Amendment to the Drawings:

REMARKS/ARGUMENTS

FIG. 2

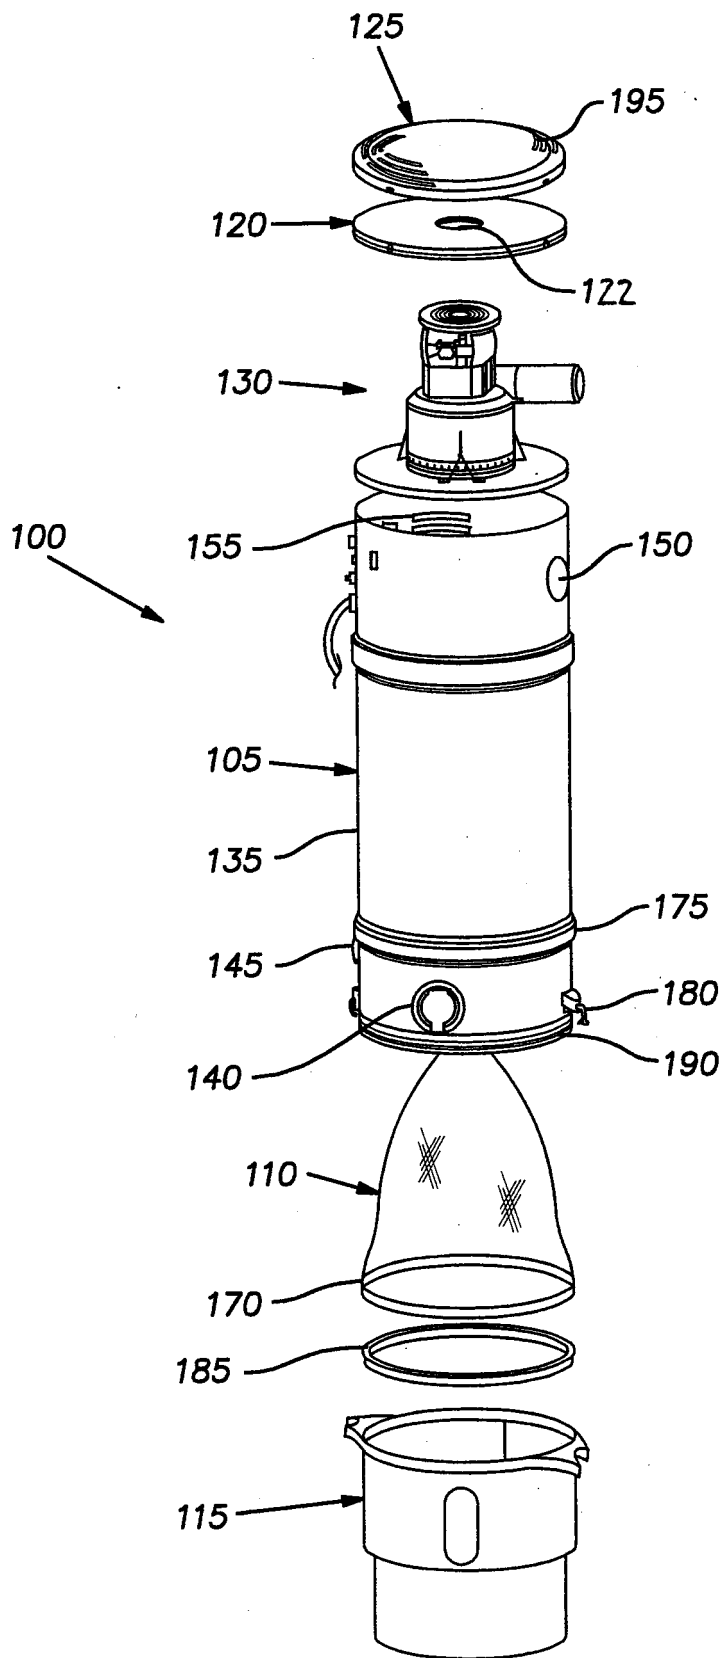
An appendix beginning on page 18 of this paper includes replacement sheets 2/5 and 3/5. These replacement sheets include changes to FIGS. 2-4. More specifically, previous reference number “185” in the upper portion of FIG. 2 has been changed to “122” to provide consistency with the specification as amended by the present amendment. Reference number “186” has been added to FIG. 3 and reference number “312” has been added to FIG. 4. These reference numbers also provide consistency with the specification as amended by the present amendment. No new matter is believed to be involved and therefore entry of the replacement sheets is respectfully requested.

In the Official action dated January 29, 2007, the examiner objected to the drawings under 37 CFR 1.83(a). More specifically, the examiner stated the vertical sealing area of the vertical gasket in claim 5 and the aperture of claim 12 must be shown or the features canceled from the claims. By way of the present amendment, claim 5 has been canceled. Moreover, the “vertical sealing area” now set forth in claim 6 is referenced with reference number “186” found in FIG. 3 of replacement sheet 3/5 of the drawings and mentioned in the amendment to the paragraph appearing on page 6, lines 15-28 of the specification. Claim 12 has been amended to remove “the aperture”. Accordingly, applicant respectfully requests withdrawal of the objection of the drawings under 37 CFR 1.83(a).
